DELEGATED DECISIONS BY CABINET MEMBER FOR TRANSPORT MANAGEMENT

KINGSTON BAGPUIZE & LONGWORTH: A420 & SIDE ROADS – PROPOSED 50MPH & 40MPH SPEED LIMITS

Report by Director of Environment and Highways

A420 Kingston Bagpuize
bypass West end
Proposed 40mph and 50mph
Speed Limit
Sheet 1 of 1

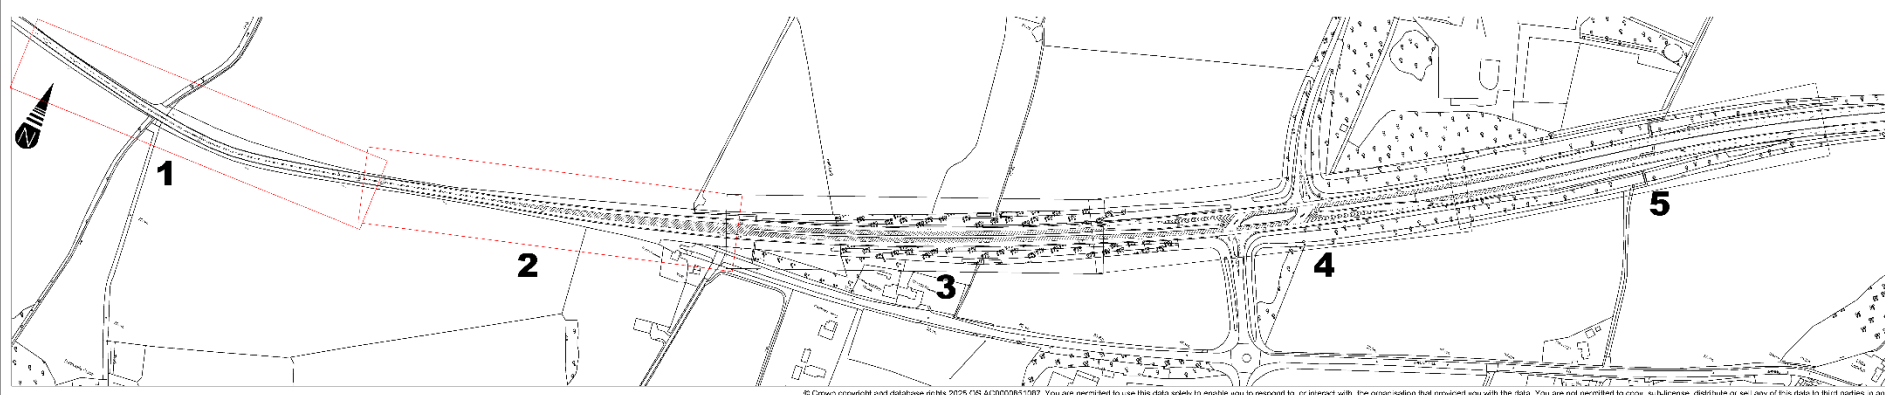
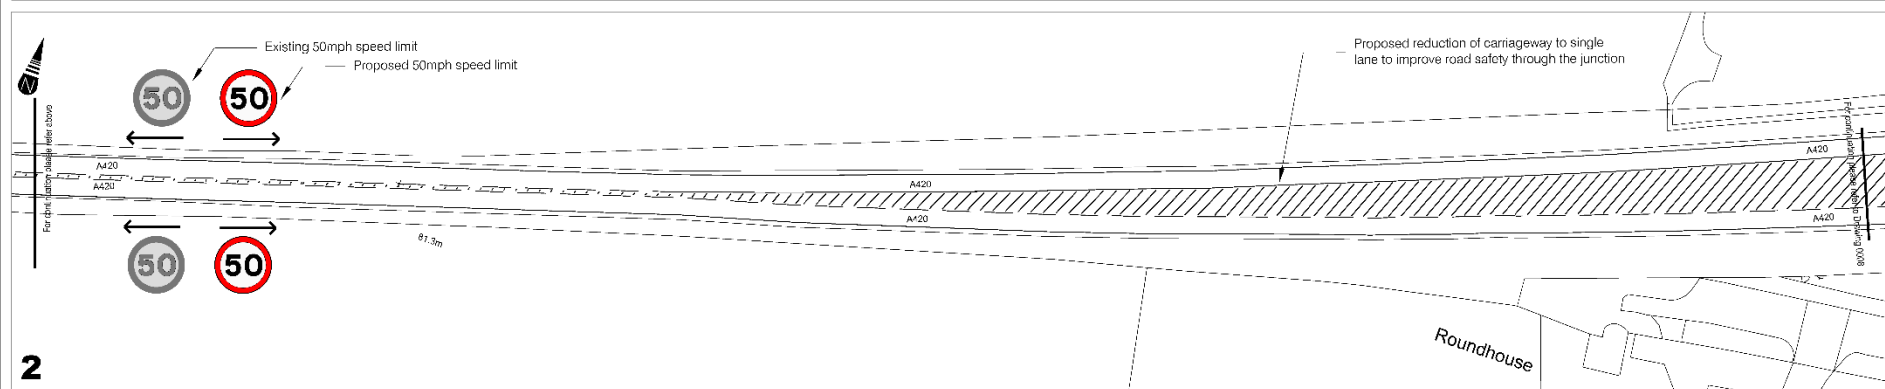
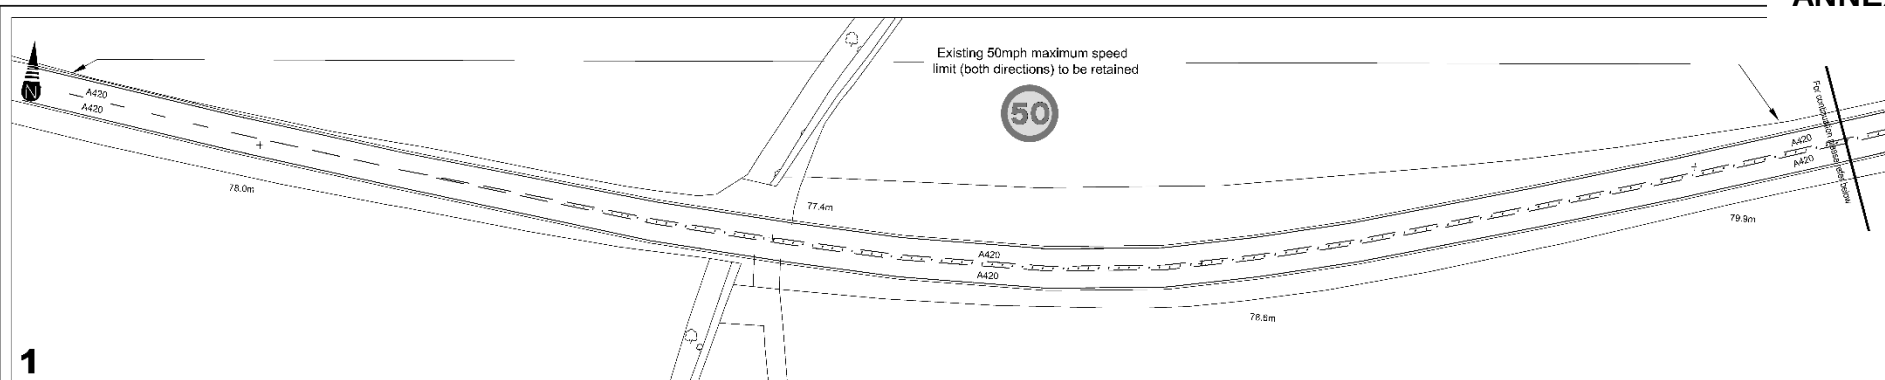
18. Additionally, a further three emails were received directly – with Thames Valley Police not objecting but raising concerns regarding potential levels of compliance. They also felt the best solution would be to ‘close’ the central reservation but understand the wider context – the proposed lining improvements were also considered necessary should the limits be reduced.

22. The majority of consultation respondents (55%) are in support of the reduction to 50mph on the A420. It appears that many of the objections have considered the speed limit proposals in isolation and have not been aware of the intended amendments to the junction layout.

23. Many respondents believe the current speed limits are appropriate for the road's character. They argue that reducing the limit to 50mph would create unnecessary delays and not address the root causes of safety concerns. Some feel that lowering speed limits can decrease driver awareness, making the road more dangerous rather than safer.

24. Several objectors doubt that drivers will comply with the new 50mph limit, especially on a dual carriageway where higher speeds feel natural. There is scepticism about enforcement, with some suggesting that without speed cameras, the new limit will be widely ignored.

25. Some respondents question whether there is sufficient evidence that a 50mph limit will reduce accidents at this location. Some believe that if accident history highlights specific locations, targeted safety measures (e.g. improved signage, junction redesign, slip roads, or roundabouts) would be more effective than a corridor-wide speed reduction.

26. Concerns are raised about the A420's role as a key strategic corridor. Objectors argue that a 50mph limit could cause platooning behind slower vehicles, increase journey times, and divert traffic onto less suitable local roads. Some worry that reducing the speed limit will lead to bunching, braking, and acceleration, which could undermine environmental aims and increase emissions.

27. Reduced speed limits are only being proposed for this section because of the likely change to the junction layout and the introduction of a single lane in each direction. As it is a 1.4 km eastward extension of the existing single lane and 50 limit, it means that approximately 1.8 km of two-lane dual carriageway remains to/from the A415 roundabout – this should still provide adequate overtaking opportunities.

A420 Longworth / Charney Bassett

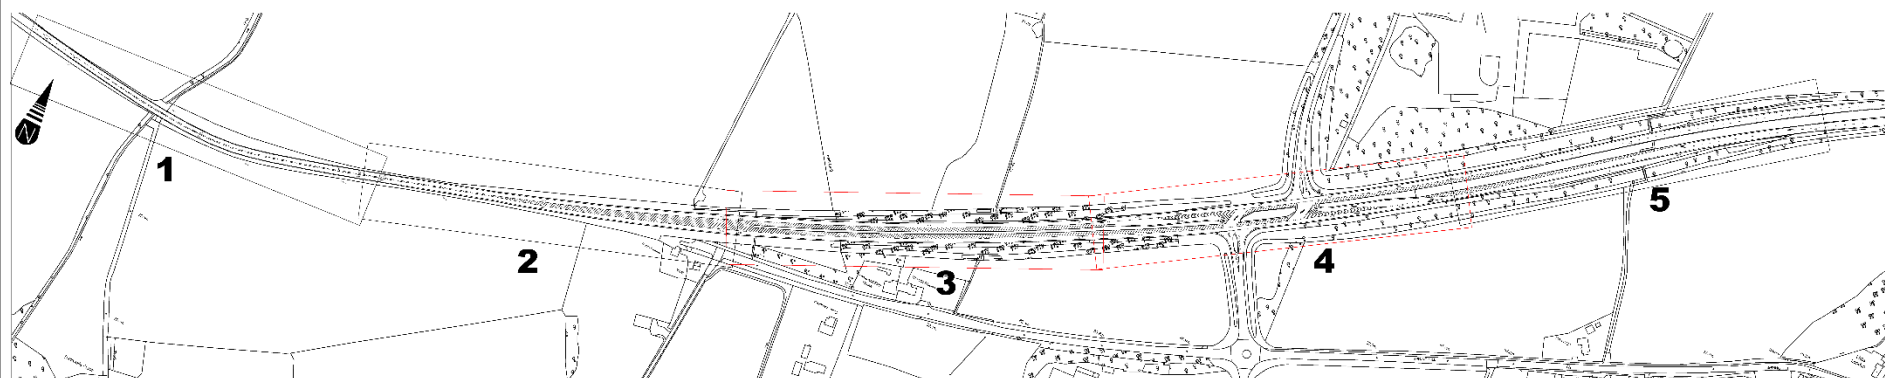
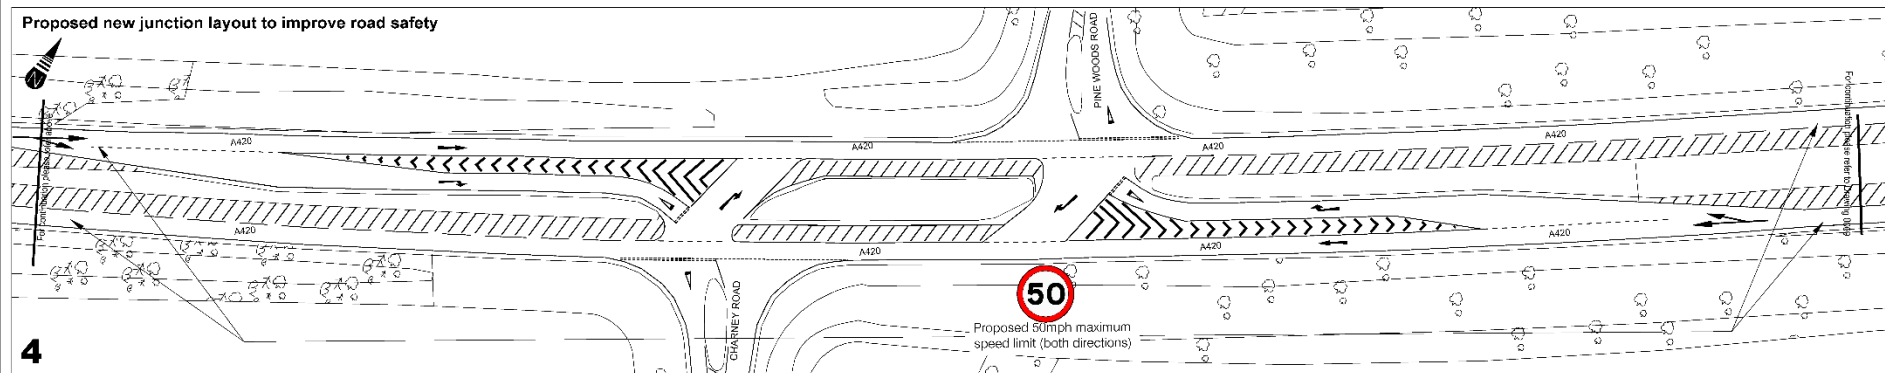
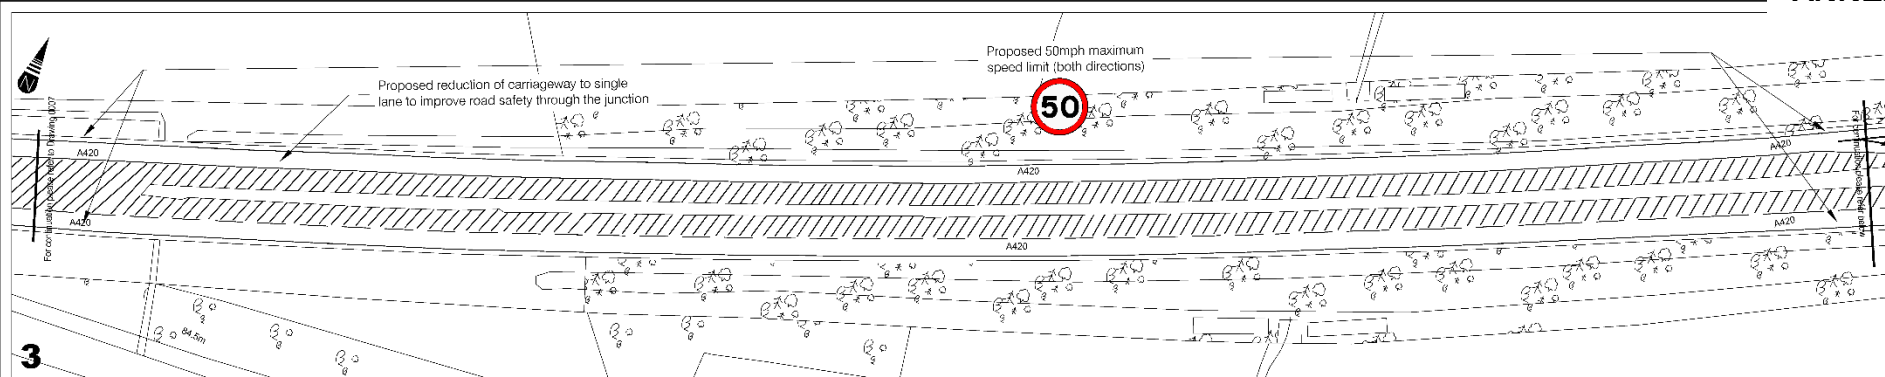
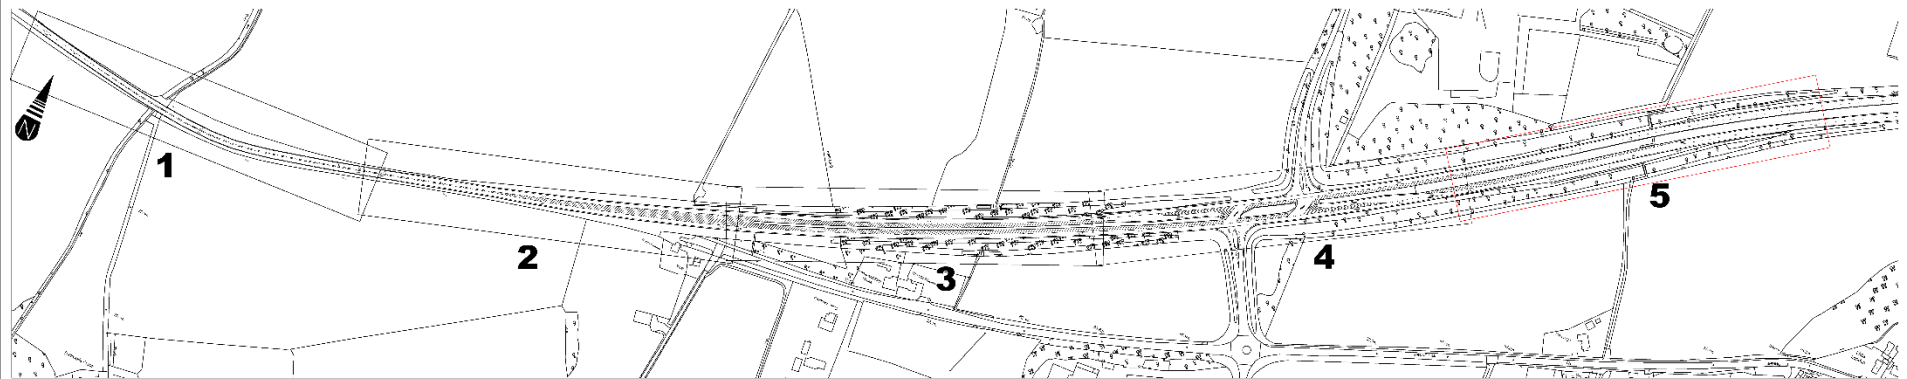
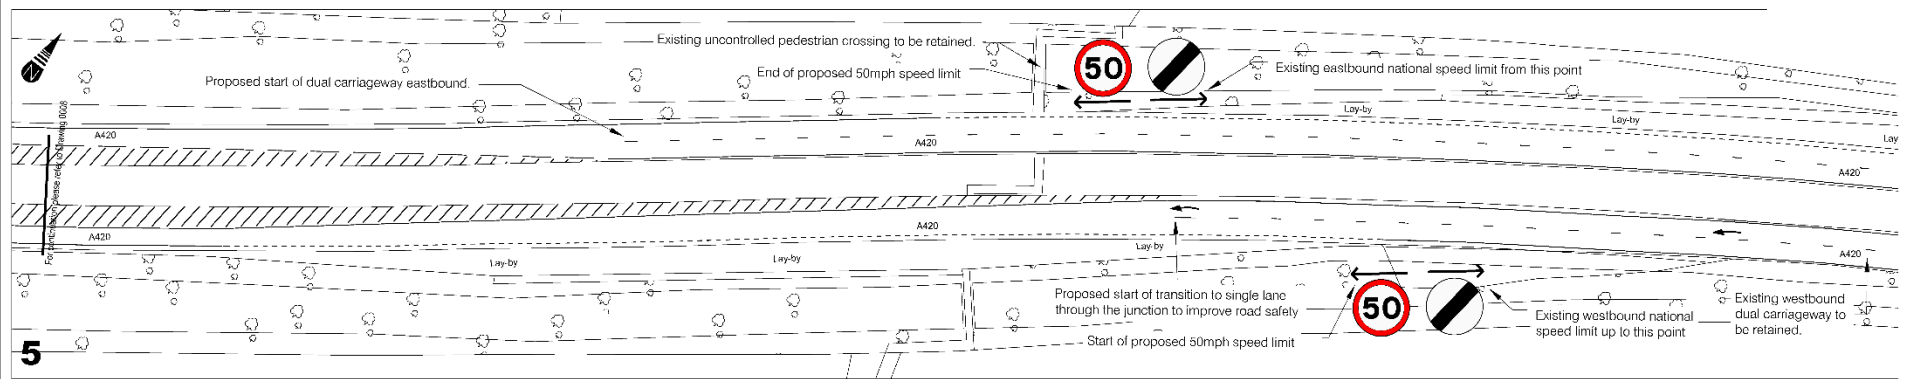
19. Unlimited Oxfordshire (local group for the disabled) supported the proposals but recommended minor amendments to the proposed lining scheme (to be considered outside of this consultation), whilst a local resident (who suggested lower speed limits here in August 2011) offered their partial support – suggesting some amendments to what was originally proposed.

28. One valid concern, from Charney Bassett Parish Council, is that drivers may be tempted to use the wide hatched areas for overtaking, which may then bring them into conflict with vehicles crossing the central area. The suggested use of bollards in the hatching was considered by officers but has not been taken forward, as it was thought best not to introduce obstructions which may be struck and could leave fixings projecting from the carriageway surface. The layout proposals will be subject to the Road Safety Audit procedure, so are open to amendment.

RESPONDENT	COMMENTS
(e1) Traffic Management Officer, (Thames Valley Police)	No objection – My first option for this location would have been to close the central reserve ,however I fully understand the impact this would have on Public Transport serving the villages of Kingston Bagpuize and Southmoor. Therefore although I am concerned with compliance, particularly the A420 section, in principle I do not object. Can I add the Lining drawings must be include as part of this scheme.
(e2) Local group/organisation, (Unlimited Oxfordshire)	Support – I am delighted to see this proposal. I remember when the KB and Southmoor bypass was opened in 1993, and I had to negotiate this staggered junction, and I thought: "People are going to be killed and seriously injured here" and unfortunately they have been. The bypass was designed by OCC in accordance with the brief issued by the then Highway Authority, the Department for Transport; OCC were Agents for the Department for Transport. However, I suggest that, a short distance west of the junction, the hatching on the westbound carriageway should be terminated. Westbound drivers may be frustrated that they would have no good overtaking opportunity until they reached the Faringdon bypass, several miles further on. Some might overtake on the hatched area. So, allowing overtaking between the staggered junction and the end of the dual carriageway would be welcome, and it might reduce the risk of unsafe overtaking further along the A420. Further to my previous email commenting on the proposed road markings and speed limits, I have more comments to add: The proposed markings in the gaps in the central reservation will encourage drivers to approach the give-way line at the second A420 carriageway at an angle of about 45 degrees to the A420 carriageway. Drivers of lorries and vans, approaching at that angle, if there is a partition in the cab directly behind them, would not be able to see to their left along the A420 carriageway. Therefore I recommend that the markings in the central reservation should encourage drivers to approach the give-way line at a greater angle to the A420 carriageway - between 60 and 70 degrees.

21. Thames Valley Police acknowledge the safety issues with the junction as they have said that ideally the junction would be closed; however, it is recognised that this approach is not feasible. There is tacit acceptance of the revised layout of the lining scheme. TVP have a concern about compliance of the lowered speed limit but it is considered that this aspect is necessary to accompany the proposed single lane through the junction.
